Application for Modification of Major Project Approval 10_0204

Modification No. 6

Montefiore Street,
Catherine Hill Bay

Coastal Hamlets Pty Ltd

Figure 6: Rejected layout change with the impractical Outram Lane alignment deleted.

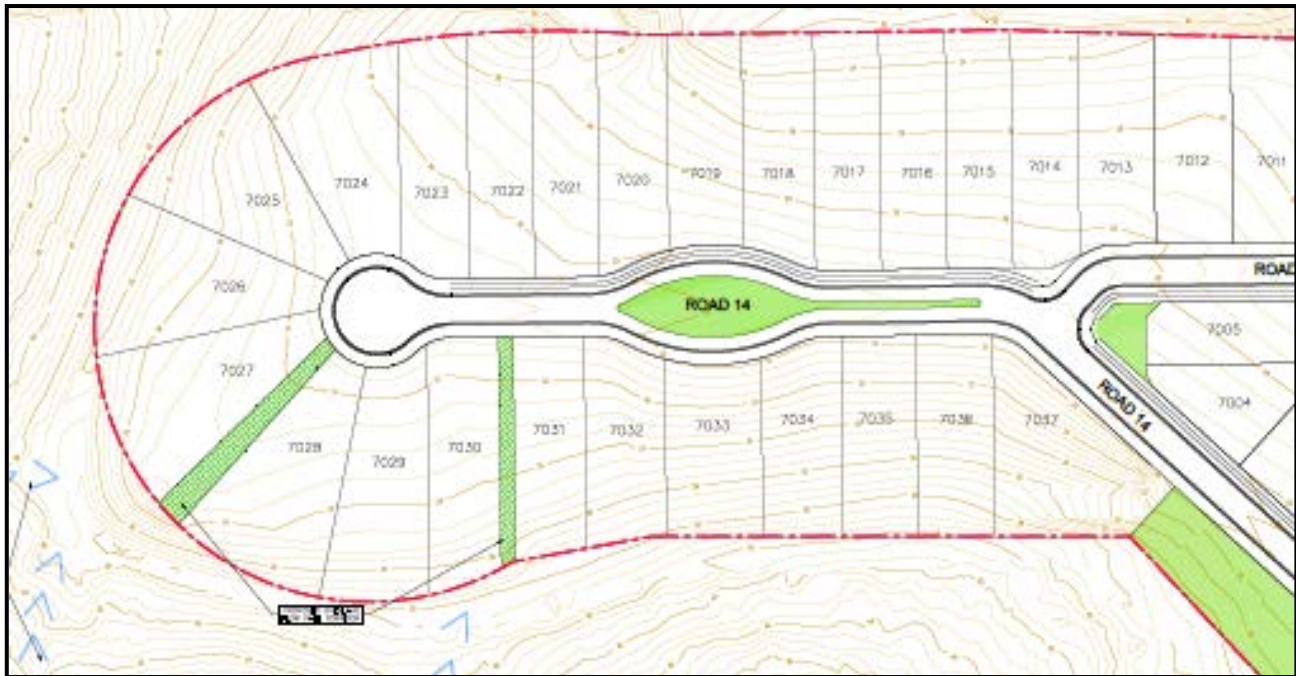
Due to topographic constraints Outram Lane cannot be practically constructed. The land is in parts too steep and would require retaining walls with dimensions regarded as poor engineering practice.

A revised proposal deleting the perimeter road, refer to **Figure 6**, was discussed with the NSW Rural Fire Service (RFS). This proposal was rejected due to bushfire considerations despite adequate bushfire asset protection zones (APZs) being available for each affected lot.

Figure 7: Proposed Stage 7 subdivision layout with the internal road removed.

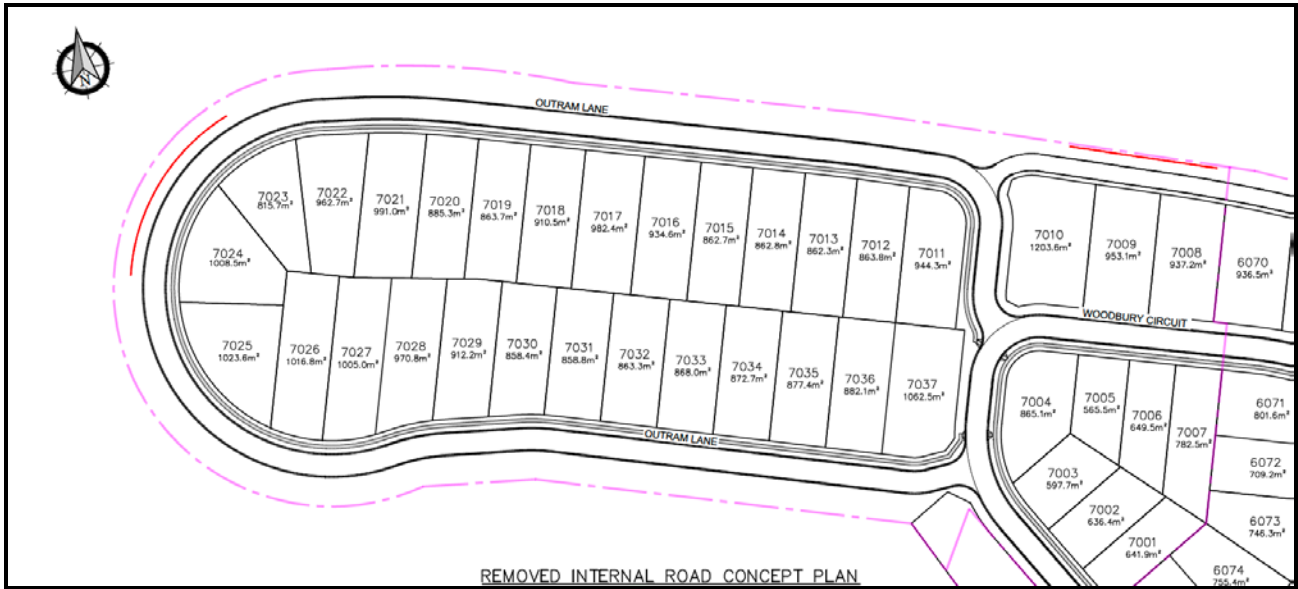
An option was developed for a realigned and upgraded Outram Lane, see **Figure 7**. The option moves the perimeter road alignment inward, away from the subdivision boundary and steeper land. The upgrading to a wider perimeter public road provides full public access to the Stage 7 lots. With all public access and bushfire requirements met by Outram Lane, Raywood Close is not needed. The plans for the revision are provided as **Appendix 1**, evidence of consultation with the RFS and Lake Macquarie City Council is provided as **Appendices 2** and **3** respectively.

No change to the conditions of approval is required. The only change required to the approval is an update of the plan references to include the proposed revised Stage 7 layout. Revised Subdivision Plans, version BA providing for the proposed layout changes, are provided as **Appendix 4**.

I do not have any objections to the amended layout. The road width will need to comply with the Rural Fire Service's requirement for a perimeter road, which is an 8 metre wide pavement.

Figure 8: Location of approved road sections requiring 6.5 metre high retaining walls.

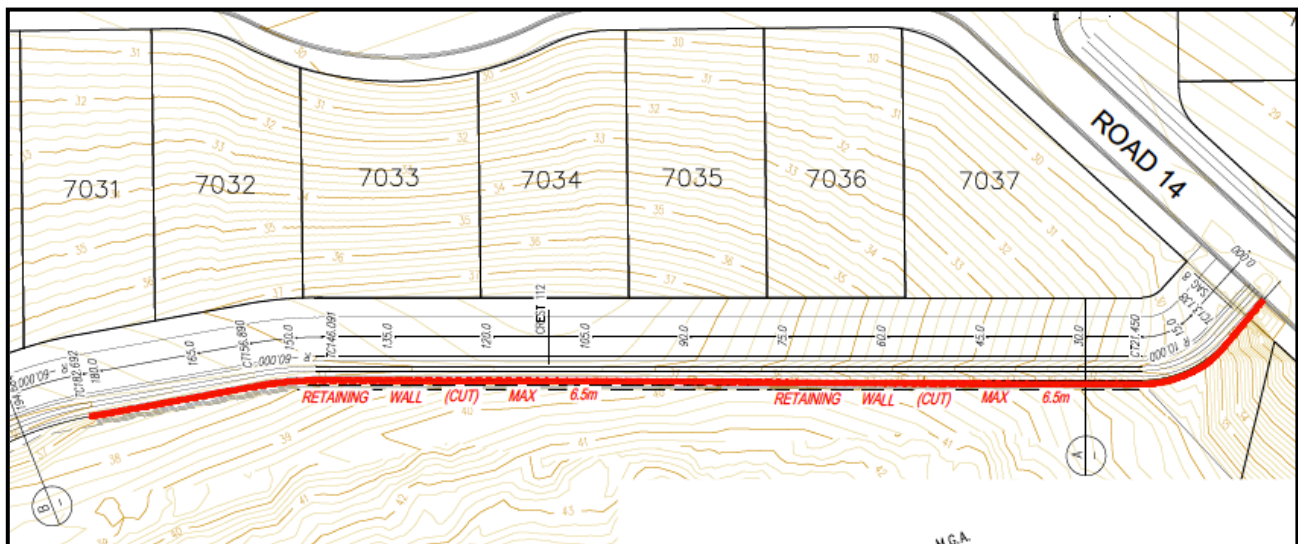
For Outram Lane as approved, application of engineering design standards and the work constraints provides for highly impractical outcomes. To achieve the required grades and drainage, retaining walls up to 6.5 metres high are required. The topography is unsuitable for the road alignment as approved. The retaining walls would be likely to generate a long term maintenance responsibility and liability for Lake Macquarie City Council (LMCC) well out of proportion to local traffic requirements. The perimeter road requirement is unreasonable as approved.

Figure 9: Engineering sections of required extent of cut fill and retaining walls as approved.

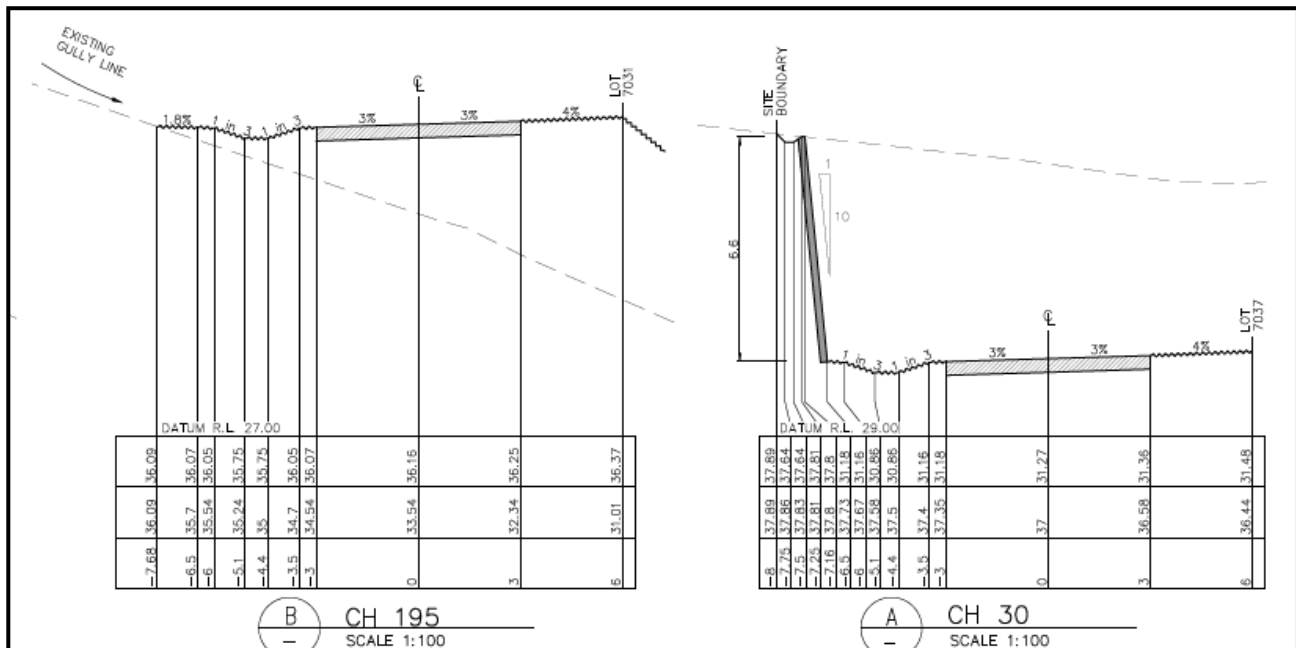
Engineering sections demonstrating the extent of required works under the current approval are provided as **Figure 9**. Some sections of Outram Road require substantial fill to achieve required grades while others require high retaining walls. The plans and sections show the poor match of road to topography as approved.

drawing title:
**"BEACHES"
CATHERINE HILL BAY
STAGE 7
LOT LAYOUT COMPARISON**

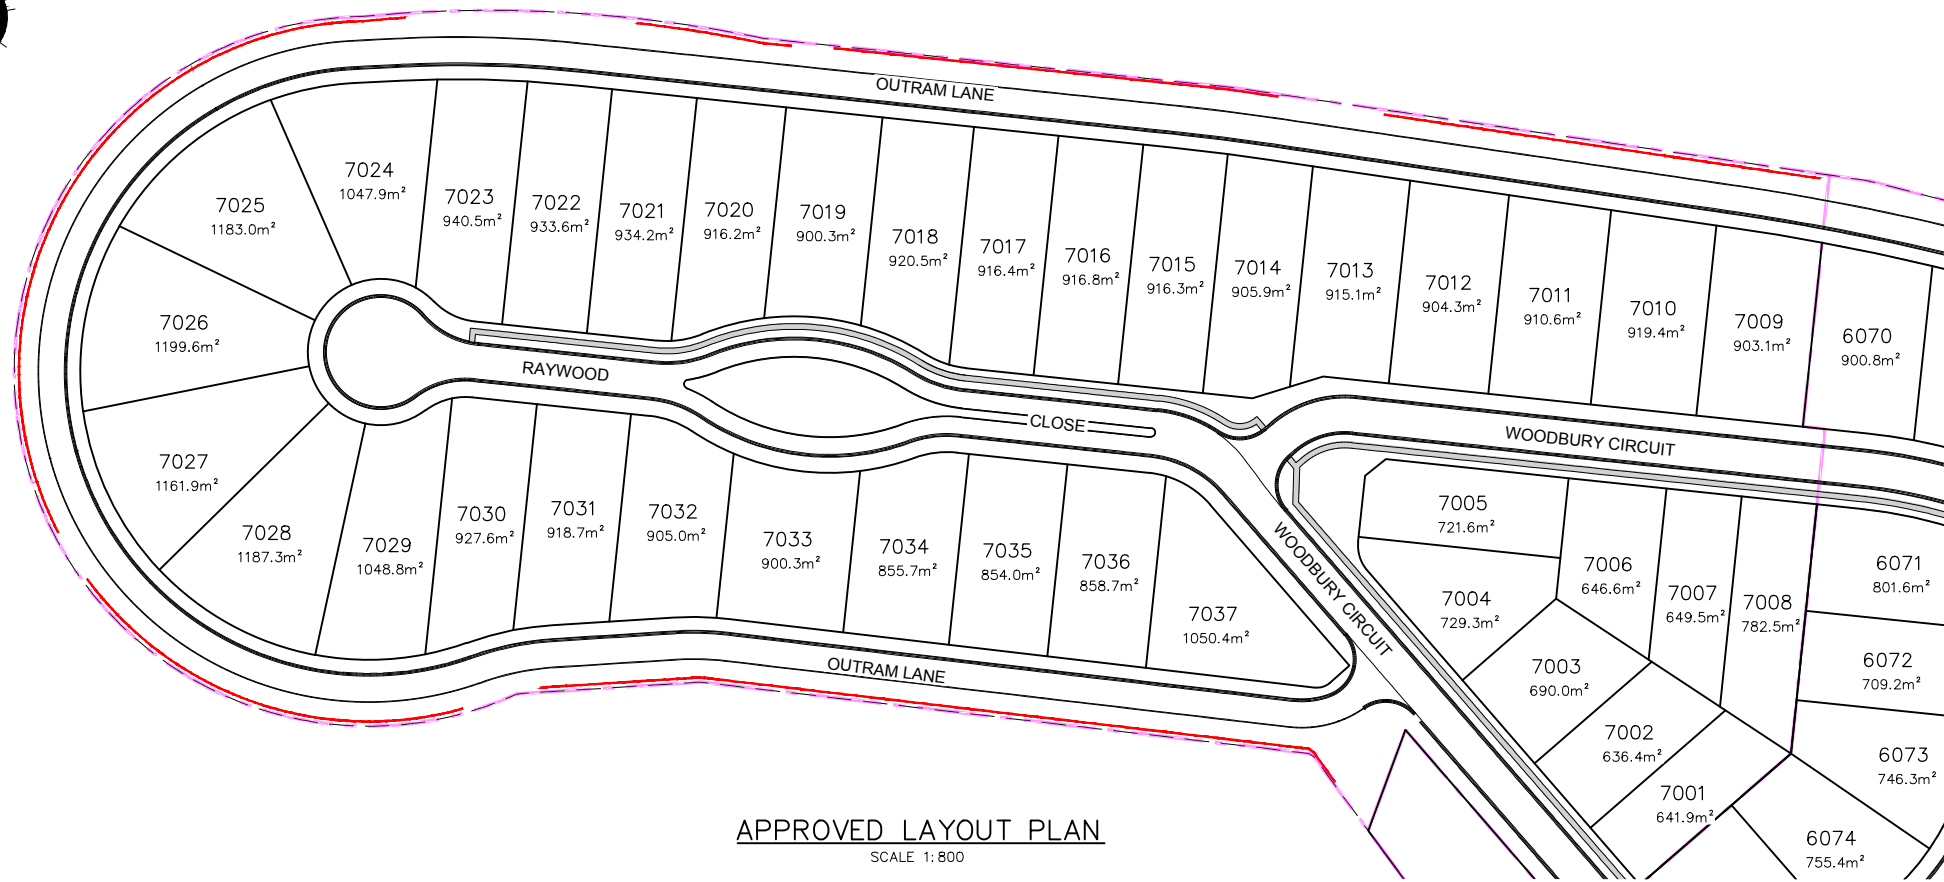
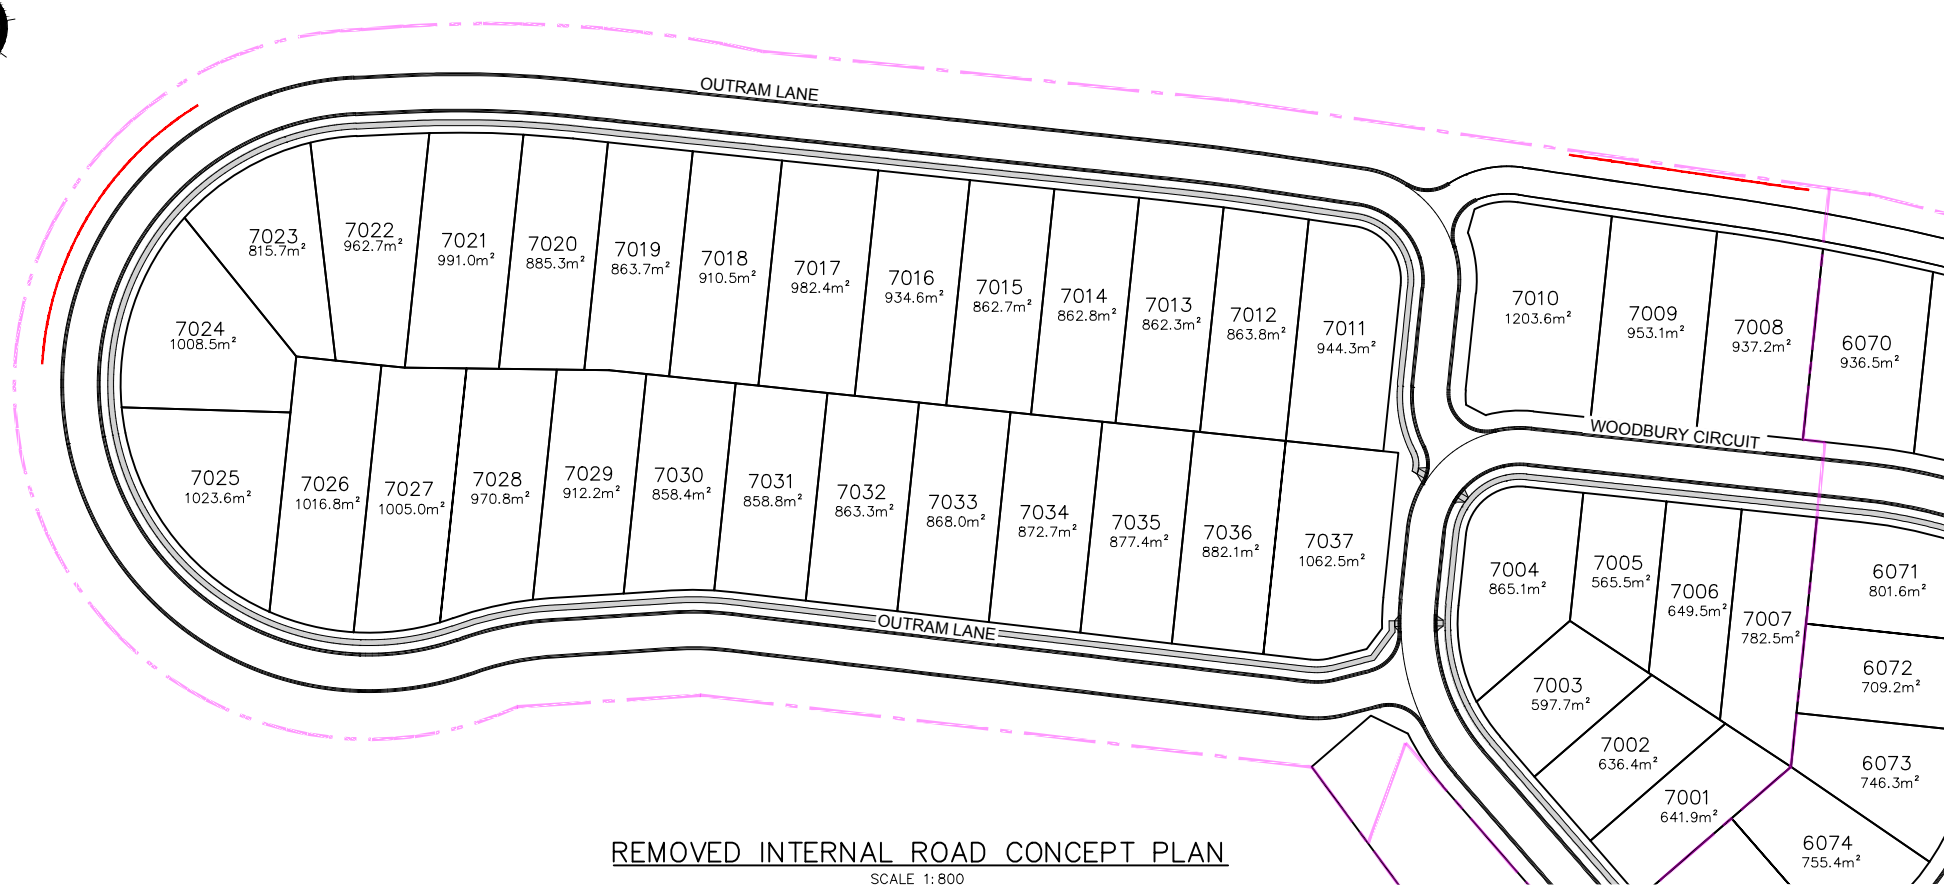
Residential subdivision Deletion of the internal spine road and modified lot layout.

A perimeter road is the preferred option to separate bushland from urban areas. It provides distinct edge of the asset protection zone. Easy, safe and quick access to the bushland interface for firefighting is proposed to be removed. Clear control line from which to conduct hazard reduction or back burning operations proposed to be removed.
The internal spine road, Raywood Close, does provide a good secondary access, but an alternate access is not a requirement of *Planning for Bush Fire Protection 2006*.

- The perimeter road shall meet the acceptable solutions of S. 4.1.3 (1) of *Planning for Bush Fire Protection 2006*.
- Future dwellings shall be able to conform to the deemed to satisfy arrangements under the Nation Construction Code (NCC) – Bushfire Attack Level BAL 29 of Australian Standard AS3959 *Construction of buildings in bushfire – prone areas* at the front building setback.
